ALERT SERVICE BULLETIN

NO. 205-00-79

MODEL AFFECTED: 205A1

SUBJECT: MAIN HYDRAULIC SERVO ACTUATOR ROD
END LOCK WASHER, INSPECTION AND
REPLACEMENT OF

Locking Washer Inspection Area
Figure 1

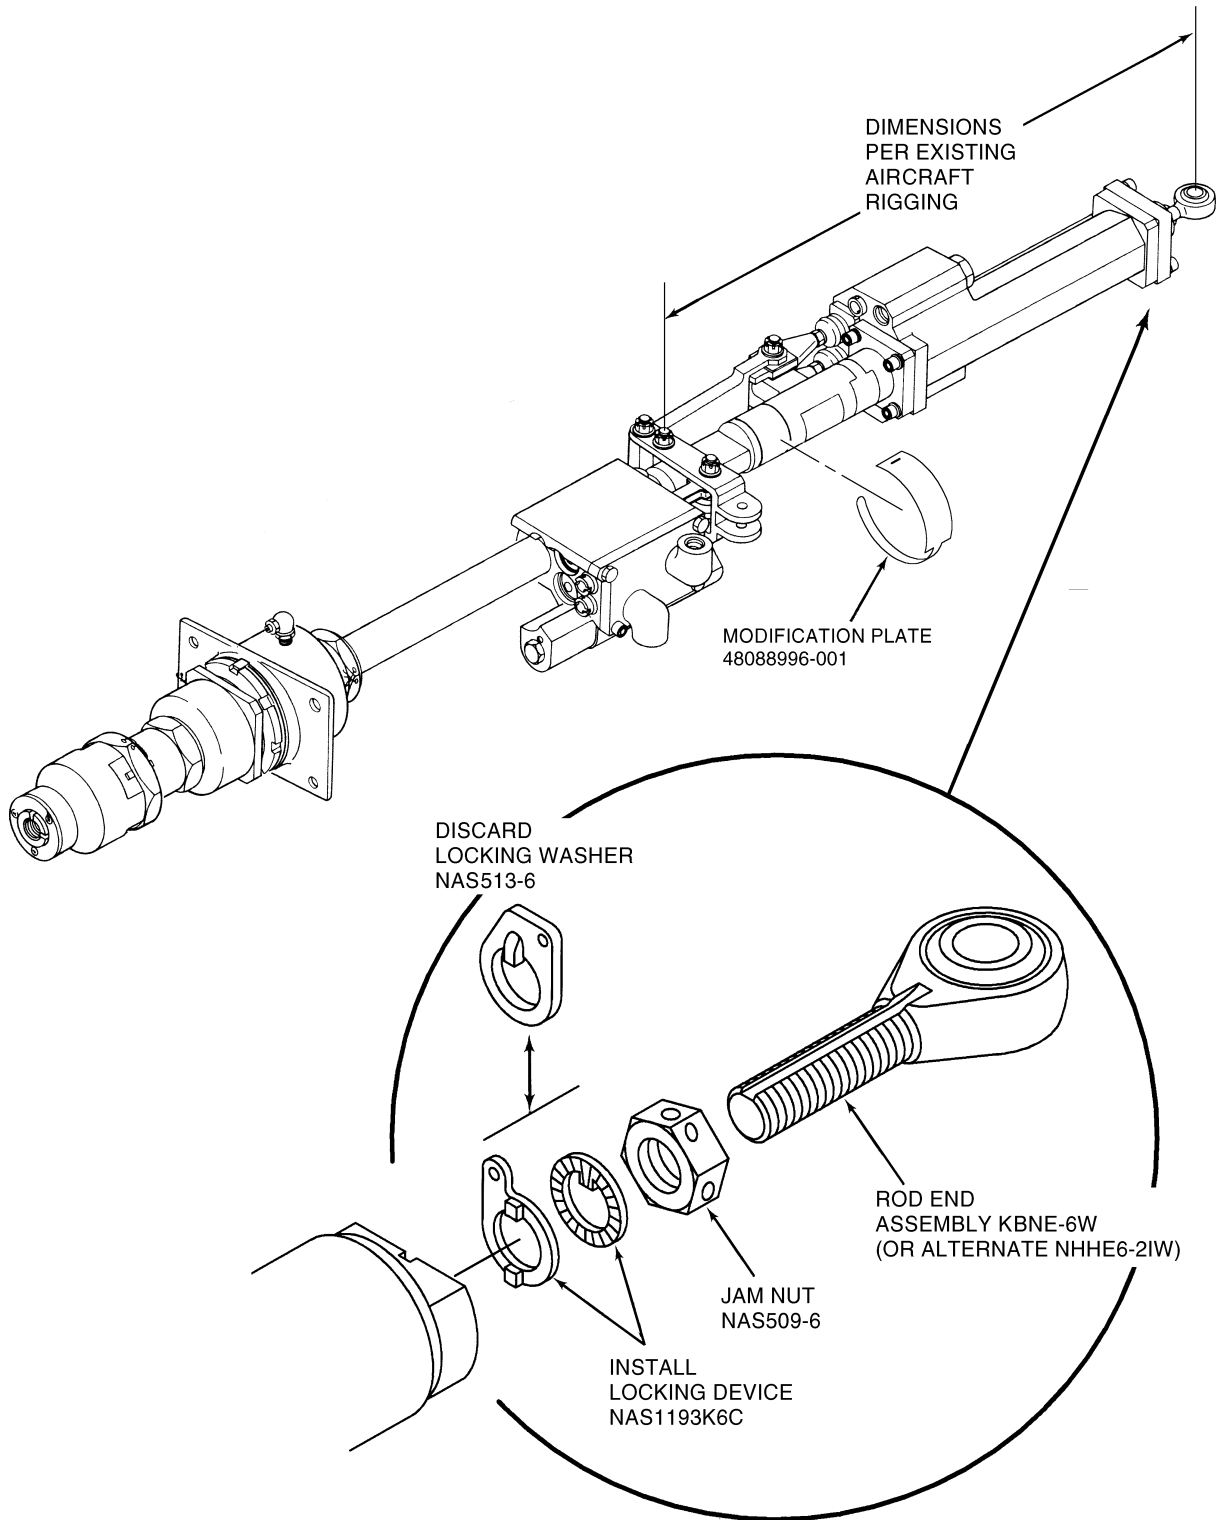
- (1) Without removing actuator from aircraft, gain access to locking washer (Figure 1).
- (2) Visually inspect locking washer to ensure it is not broken. Tab shall be in groove of rod end assembly. Immediately replace any locking washer whose tab is twisted or hanging askew.

- (a) Cut and remove lockwire from between jam nut and locking washer.
 - (b) Ensure that tab on locking washer is engaged into nearest radially located slot in end of piston.

- (c) Use one wrench to hold and secure rod end assembly while using second wrench to tighten jam nut 200 to 250 inch-pounds. Do not use first wrench to hold piston assembly and turn jam nut with second wrench, as is the typical convention. This method may catch and turn the rod end, which strips the tab from the locking washer.

- (d) Visually inspect locking washer to ensure it was not damaged during torque operation. Tab shall be in groove of rod end assembly. Immediately replace any locking washer whose tab is twisted or hanging askew.

- (1) There are two options to replace the washer: with actuator in place on aircraft; or with actuator off aircraft during shop overhaul. If replacing during overhaul, refer to CMM 67-31-02 and use locking device NAS1193K6C in place of locking washer NAS513-6. If replacing with actuator on aircraft, proceed as follows:
 - (2) Disconnect rod end assembly from aircraft attachment point.
 - (3) Bottom piston in cylinder, then measure dimension from centerline of rod end assembly to centerline of pivot point for input lever assembly (Figure 1). Record dimension for later use.
 - (4) Cut and remove lockwire from between jam nut and locking washer.
 - (5) Use one wrench to hold flats of rod end assembly. With rod end assembly thus secured, use second wrench to loosen jam nut.

- (6) Remove rod end assembly from threads of piston assembly. Remove locking washer from rod end assembly and discard locking washer.
- (7) Carefully install new 2-piece locking device NAS1193K6C onto rod end assembly. Refer to Figure 1 and the following substeps:
 - (a) Install round ring onto threaded rod so that tab fits into groove on rod end and serrated side faces away from jam nut.
 - (b) Install oblong ring onto threaded rod so that serrated side will engage serrated side of round ring.
- (8) Install rod end assembly into threads of piston assembly. With piston assembly bottomed in cylinder assembly, establish the same dimension that was recorded in step 3.
- (9) Slide oblong ring (part of new locking device NAS1193K6C) so that two locking tabs fit into slots on end of piston assembly. Slide round ring (also part of new locking device NAS1193K6C) to engage oblong ring.

- (10) Using two wrenches to protect locking device from damage resulting from inadvertent rotation of rod end, apply torque of 200 to 250 inch-pounds to jam nut NAS509-6. Use one wrench to hold and secure rod end assembly while using second wrench to tighten jam nut. Do not use first wrench to hold piston assembly and turn jam nut with second wrench, as is the typical convention. This method may catch and turn the rod end, which strips the tab off the locking device.

Figure 1

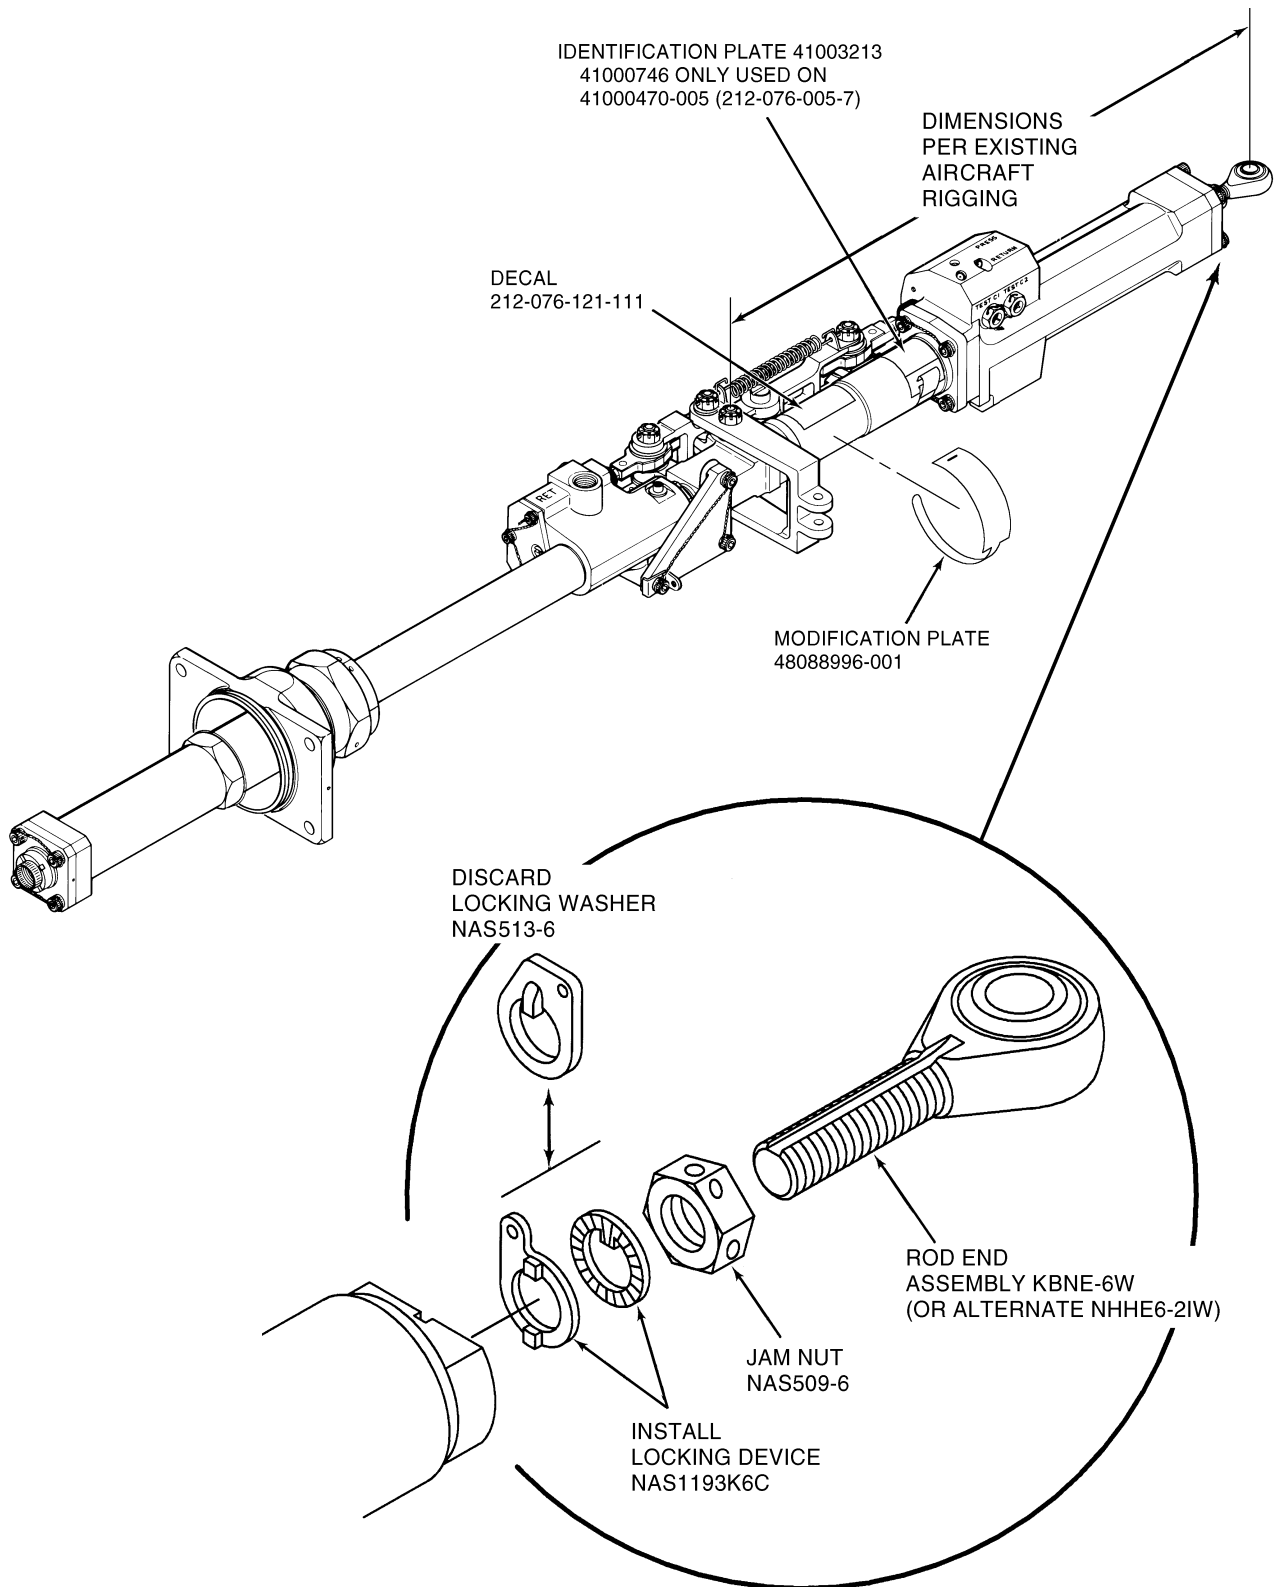
- (1) Without removing actuator from aircraft, gain access to locking washer (Figure 1).
- (2) Visually inspect locking washer to ensure it is not broken. Tab shall be in groove of rod end assembly. Immediately replace any locking washer whose tab is twisted or hanging askew.

- (a) Cut and remove lockwire from between jam nut and locking washer.
 - (b) Ensure that tab on locking washer is engaged into nearest radially located slot in end of piston.

- (c) Use one wrench to hold and secure rod end assembly while using second wrench to tighten jam nut 200 to 250 inch-pounds. Do not use first wrench to hold piston assembly and turn jam nut with second wrench, as is the typical convention. This method may catch and turn the rod end, which strips the tab from the locking washer.

- (d) Visually inspect locking washer to ensure it was not damaged during torque operation. Tab shall be in groove of rod end assembly. Immediately replace any locking washer whose tab is twisted or hanging askew.

- (7) Carefully install new 2-piece locking device NAS1193K6C onto rod end assembly. Refer to Figure 1 and the following substeps:
 - (a) Install round ring onto threaded rod so that tab fits into groove on rod end and serrated side faces away from jam nut.

- (b) Install oblong ring onto threaded rod so that serrated side will engage serrated side of round ring.
- (8) Install rod end assembly into threads of piston assembly. With piston assembly bottomed in cylinder assembly, establish the same dimension that was recorded in step 3.

- (9) Slide oblong ring (part of new locking device NAS1193K6C) so that two locking tabs fit into slots on end of piston assembly. Slide round ring (also part of new locking device NAS1193K6C) to engage oblong ring.

- (10) Using two wrenches to protect locking device from damage resulting from inadvertent rotation of rod end, apply torque of 200 to 250 inch-pounds to jam nut NAS509-6. Use one wrench to hold and secure rod end assembly while using second wrench to tighten jam nut. Do not use first wrench to hold piston assembly and turn jam nut with second wrench, as is the typical convention. This method may catch and turn the rod end, which strips the tab off the locking device.
- (11) Visually inspect locking washer to ensure it was not damaged during torque operation. Tab shall be in groove of rod end assembly. Immediately replace any locking washer whose tab is twisted or hanging askew.
- (12) Identify actuator as being service bulletin-compliant. Refer to Table 1 for identification instructions and follow steps below as applicable:
